ROHM Sensor Platform Base and Breakout Boards

Title			Sensor Platform Schematic		
Size	Document Number				Rev
B	Table of Contents/Revision History				1.0
Date:	Friday, August 01, 2014	Sheet	1	of	7

Temperature Sensors

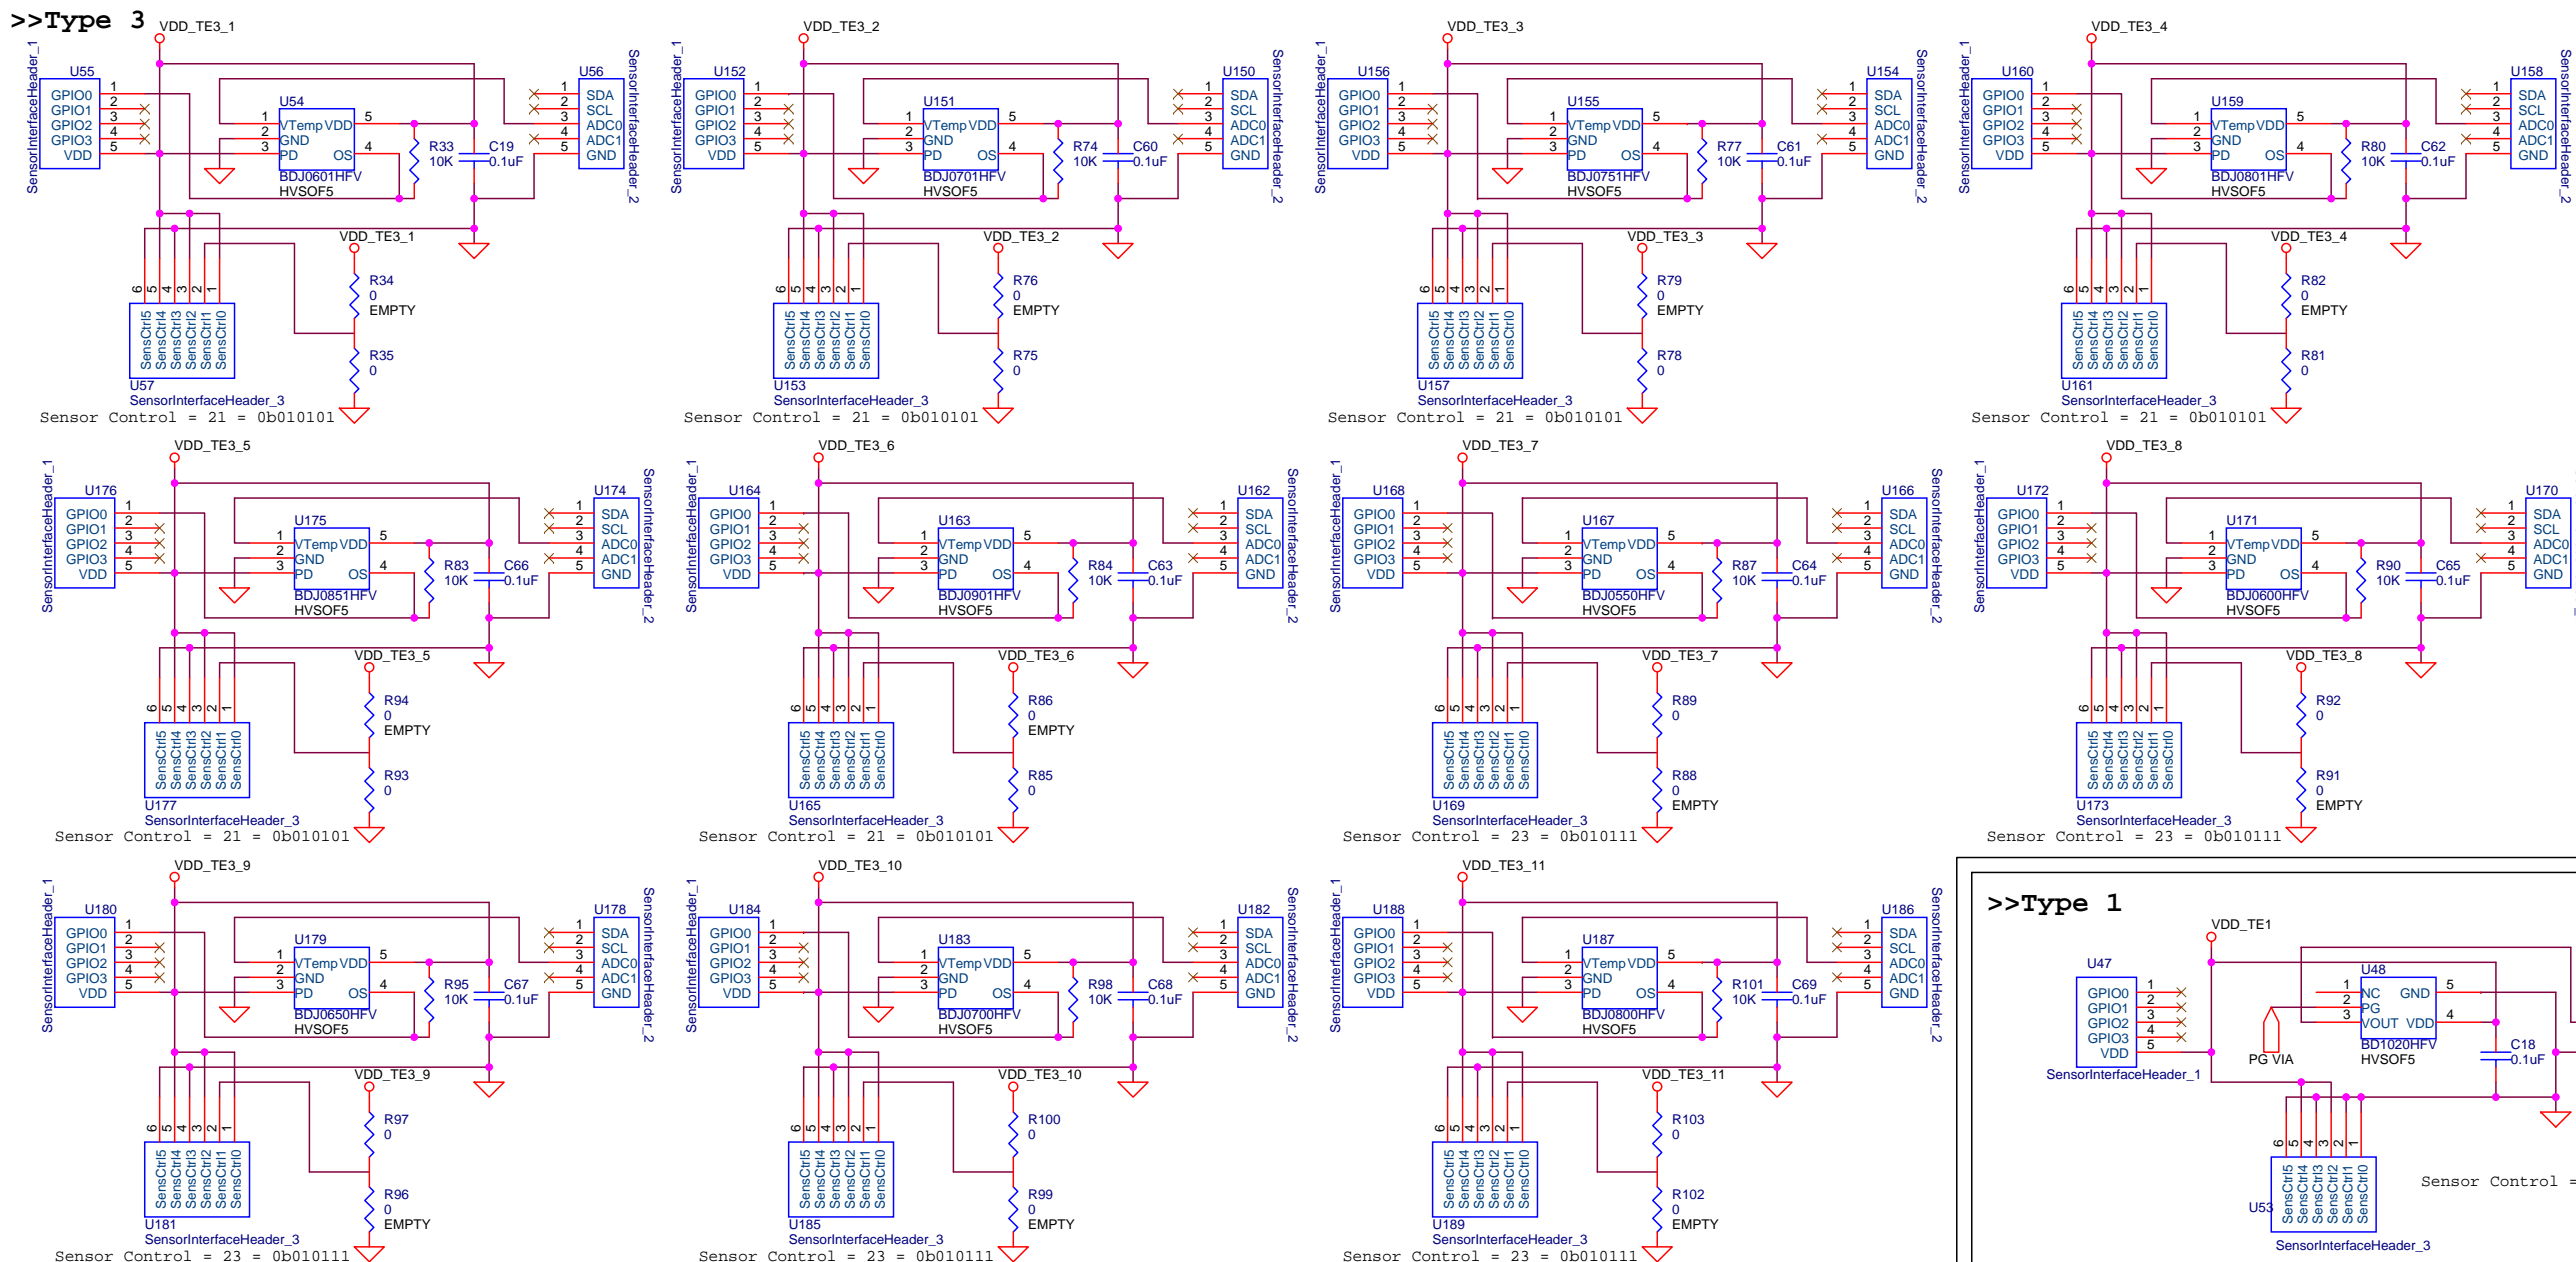
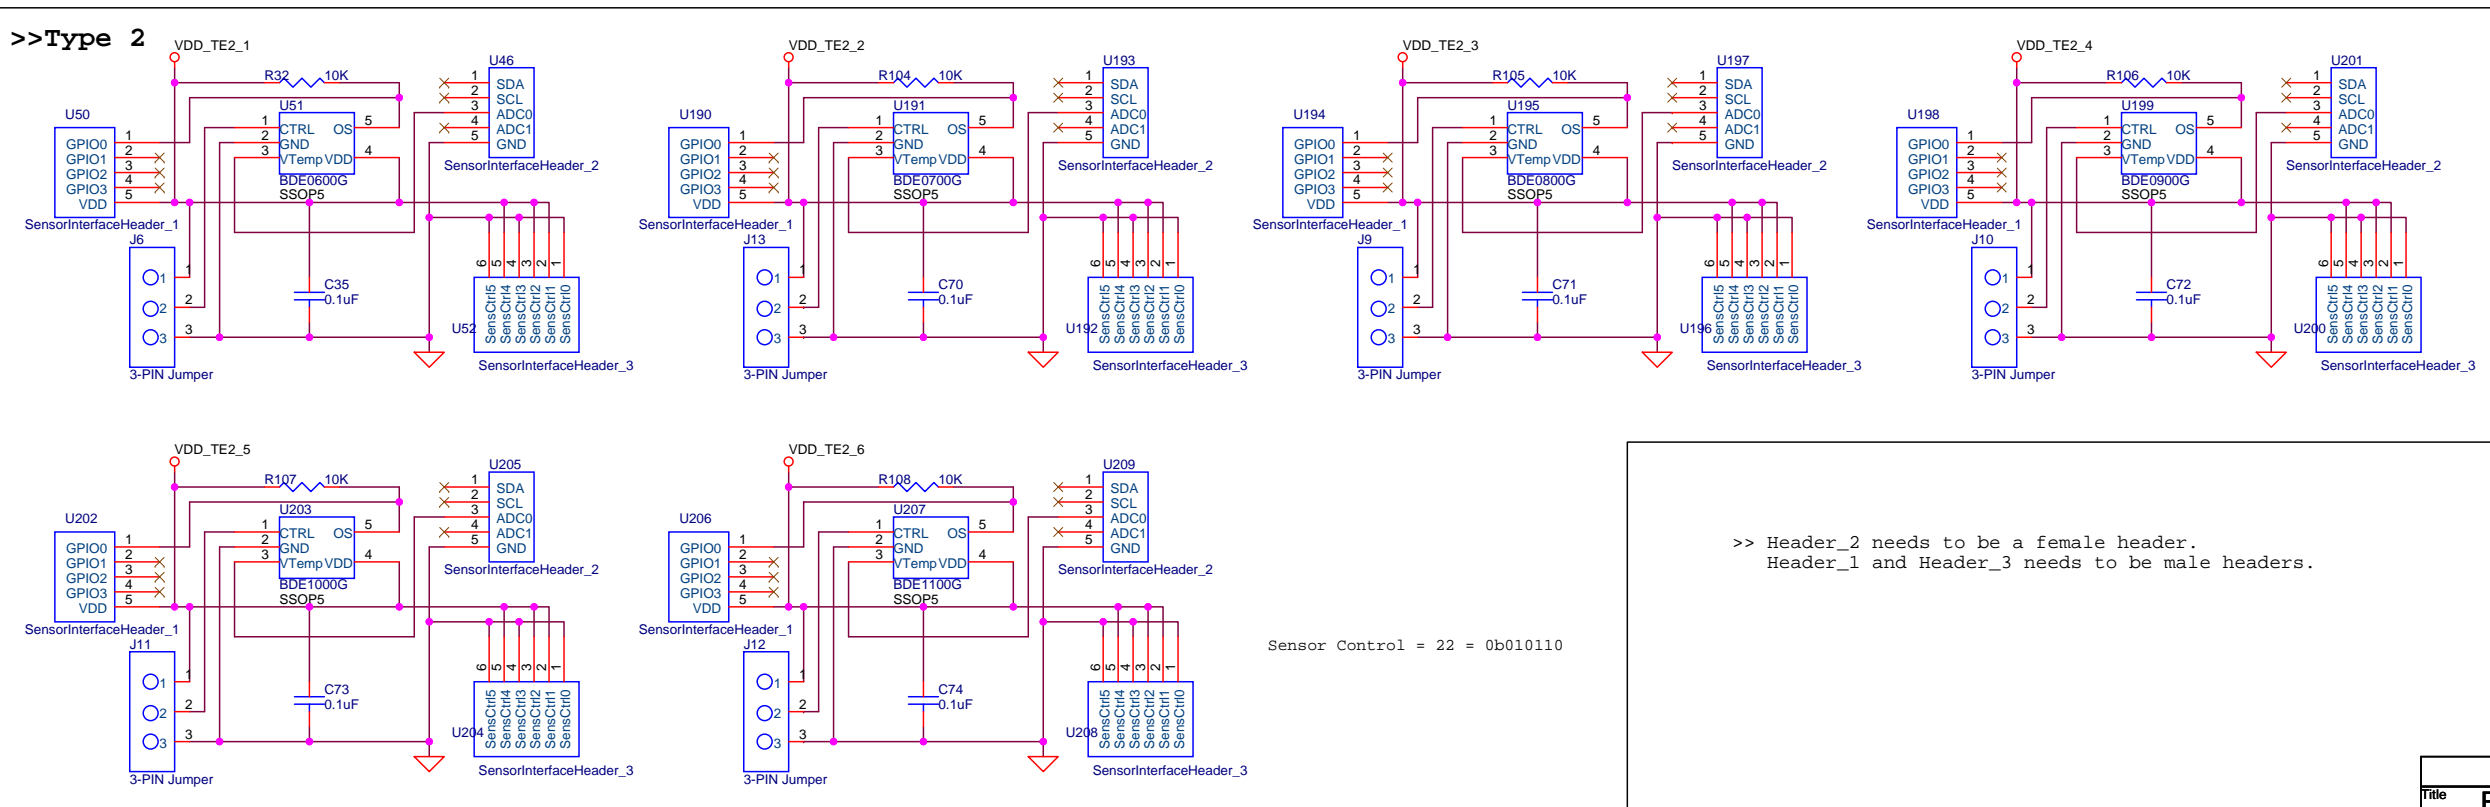
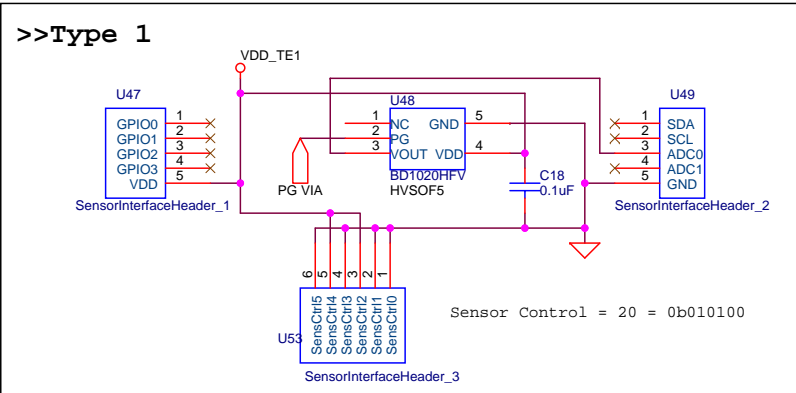
>> Header_2 needs to be a female header.
Header_1 and Header_3 needs to be male headers.

UV Sensor

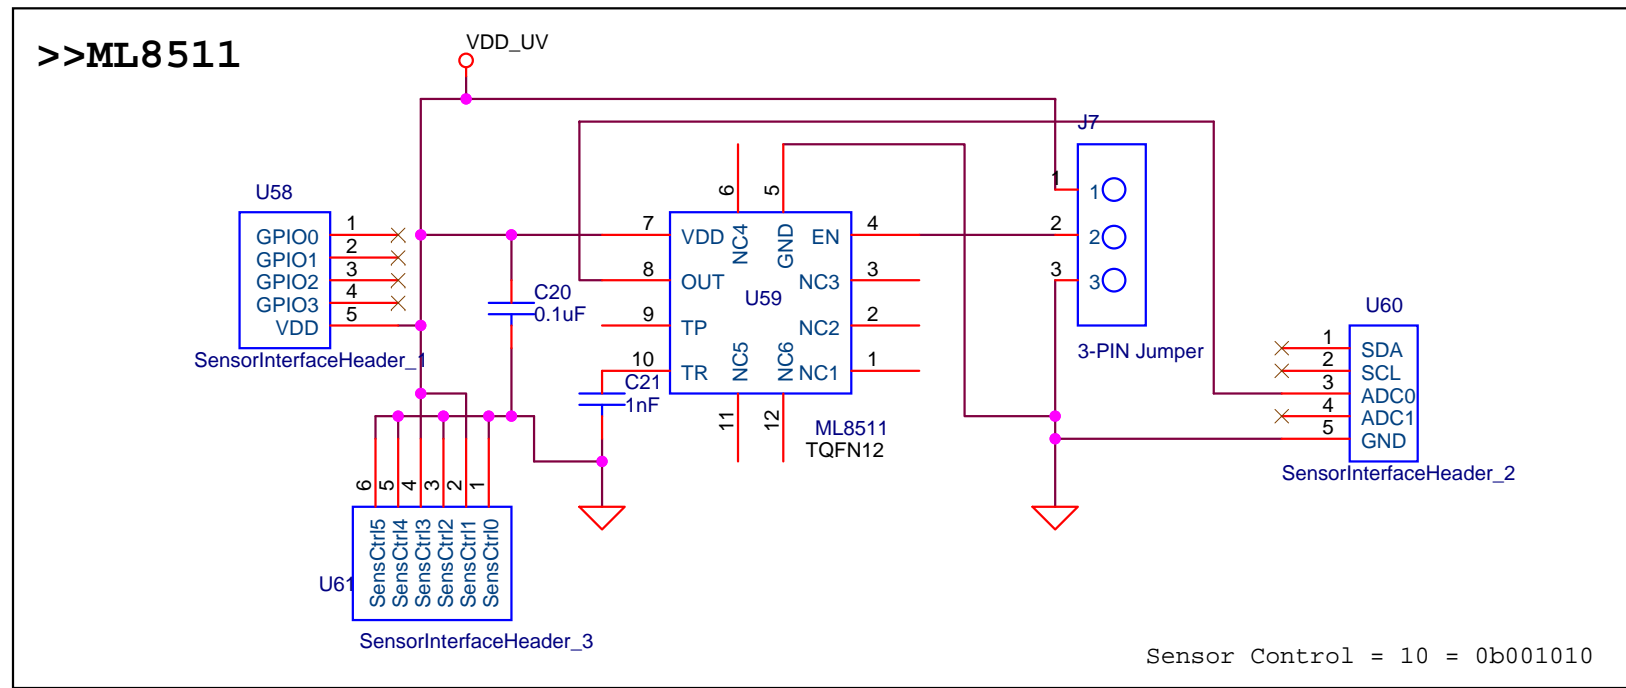
>> Header_2 needs to be a female header.
Header_1 and Header_3 needs to be male headers.
